Re: Case No. 18-1855-EL-BTA
In the Matter of the Application for Amendment of AEP Ohio
Transmission Company, Inc. for a Certificate of Environmental
Compatibility and Public Need for Yager-Desert Road 138 kV
Transmission Line Rebuild Project

**AMENDMENT TO THE APPLICATION TO THE
OHIO POWER SITING BOARD
FOR A CERTIFICATE OF ENVIRONMENTAL
COMPATIBILITY AND PUBLIC NEED**

**Yager – Desert Road 138 kV
Transmission Line Rebuild Project
January 2019**

AMENDMENT CHANGE SUMMARY

Exhibit 1: Summary of the Changes to the Preferred Route

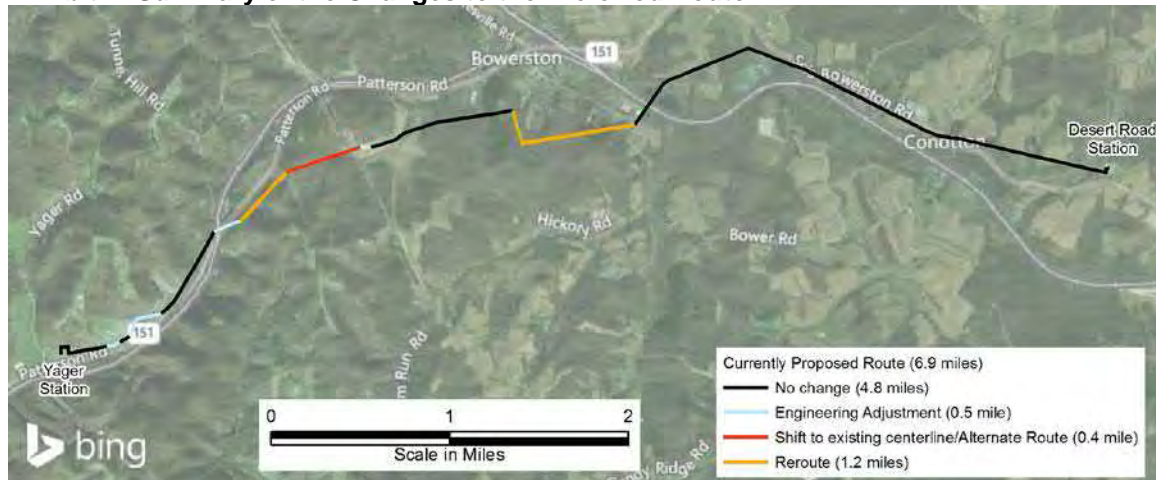
Detailed engineering and property owner negotiations resulted in seven areas of change to the Preferred Route. These changes comprise three categories: (1) engineering adjustments, (2) a shift to rebuild on existing centerline rather than offset within the existing right-of-way (ROW), and (3) reroutes that deviate from the existing or initially proposed ROW.

Exhibit 2: Engineering Adjustment 1

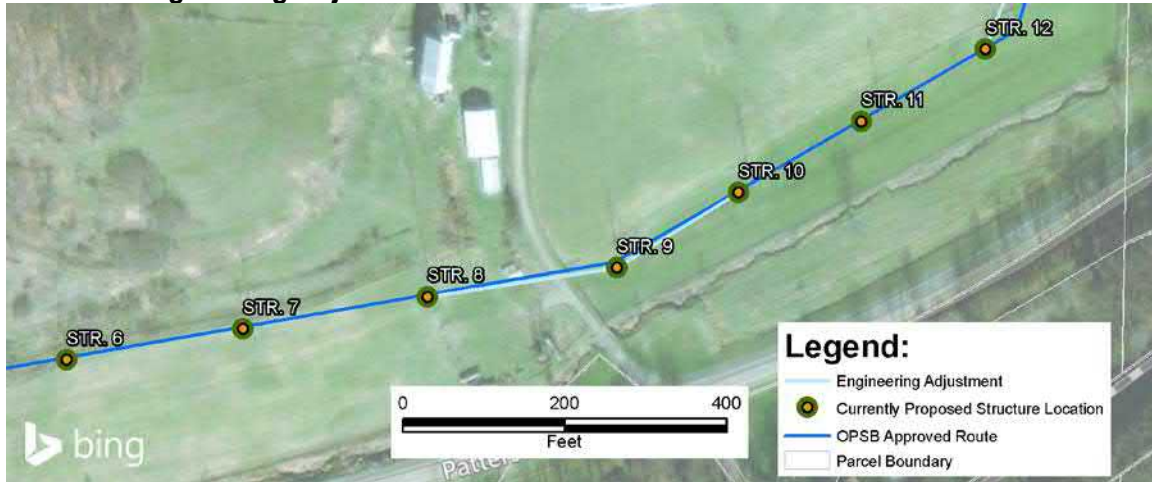
Engineering Adjustment 1 occurs at Structure 9. Detailed engineering resulted in a shift of a single structure approximately eight feet south of the OPSB-approved centerline. The total length of the shift that differs from the OPSB-approved centerline is less than 0.1 mile. The change is provided in Exhibit 2 below. This adjustment did not result in any additional or adjoining tracts being impacted or added as this was a minor shift on the existing parcel where the line currently exists.

Exhibit 4: Engineering Adjustment 3

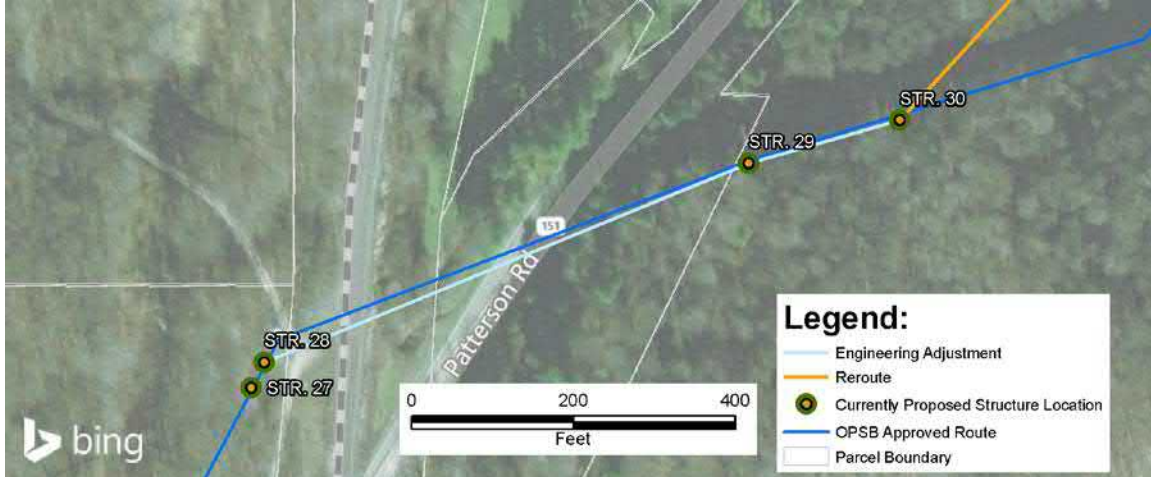
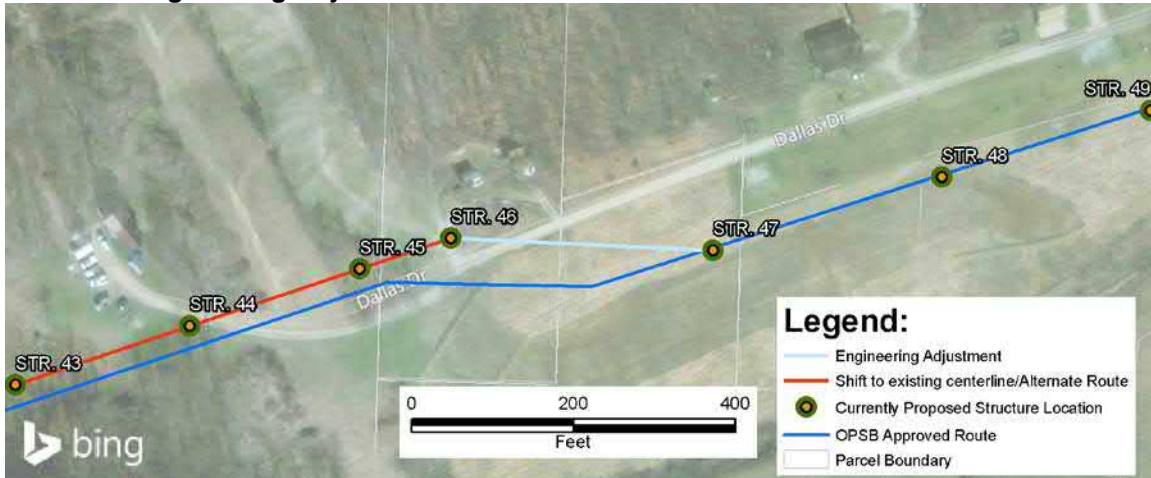
Engineering Adjustment 3 occurs between Structure 28 and Structure 30. The western pole shifted approximately 32 feet along the OPSB-approved centerline to improve the structure

location relative to a driveway. The eastern structure shifted approximately seven feet off the OPSB-approved centerline. Exhibit 4 shows the overall change. This adjustment did not impact or add any additional or adjoining tracts.

Exhibit 5: Engineering Adjustment 4

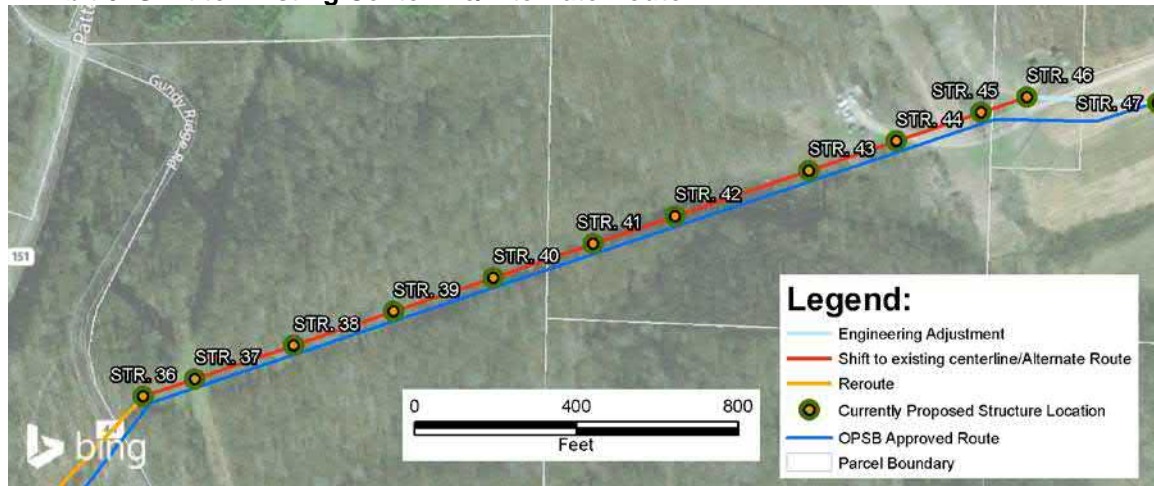
Engineering Adjustment 4 occurs between Structure 46 and Structure 47. The change is a result of a shift to the existing centerline due to a property owner preference. Exhibit 5 shows the change. This adjustment did not impact or add any additional or adjoining tracts.

Exhibit 7: Reroute 1

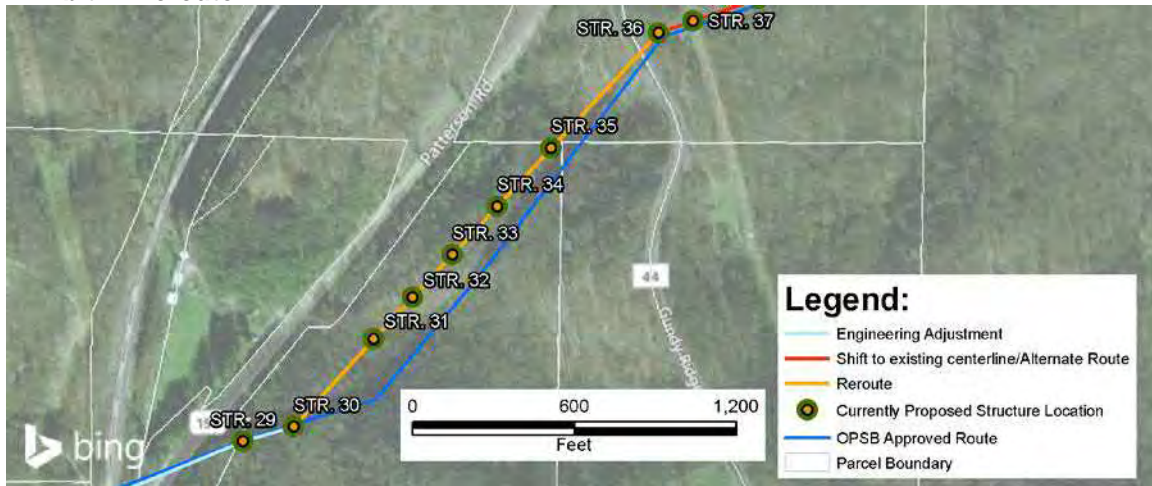
Reroute 1 is between Structure 30 and Structure 35. The location of the angle structure was shifted to avoid a natural gas line in conjunction with property owner negotiations. At its greatest difference, the reroute is approximately 150 feet from the OPSB-approved route. The total length of Reroute 1 is approximately 0.4 mile. Reroute 1 is shown on Exhibit 7. No additional tracts or landowners were impacted or added by this reroute. All property owners were agreeable and signed easements for the reroute.

Exhibit 8: Reroute 2

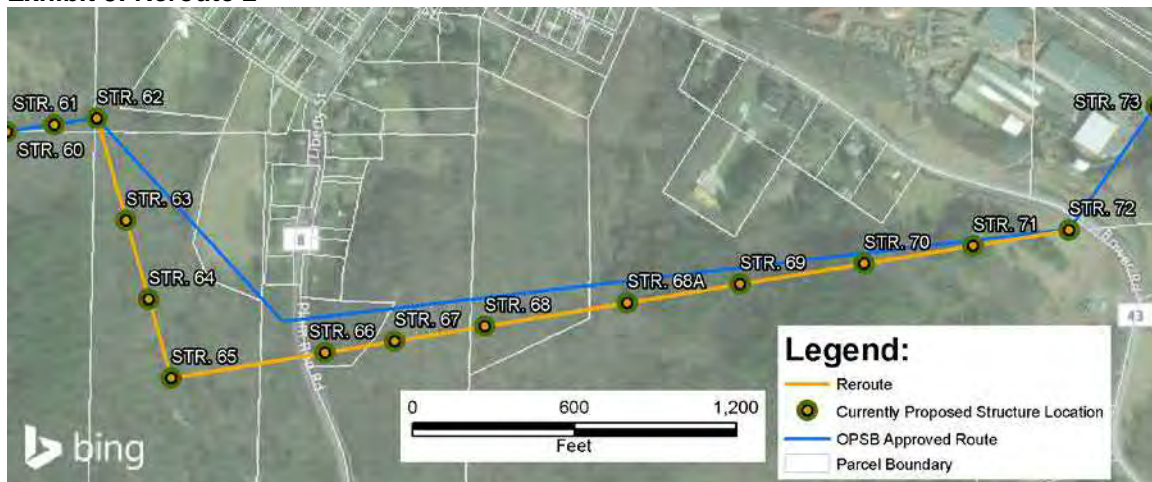
Reroute 2 is between Structure 62 and Structure 72. This 0.8-mile reroute is necessary due to a newly-identified structure in the woods. This created the need to go further south from Structure 62 than originally planned. The alignment was then further adjusted to Structure 72 as a result of terrain. Reroute 2 is shown on Exhibit 8. This reroute does not add or impact any additional tracts or landowners as compared to the OPSB approved route.
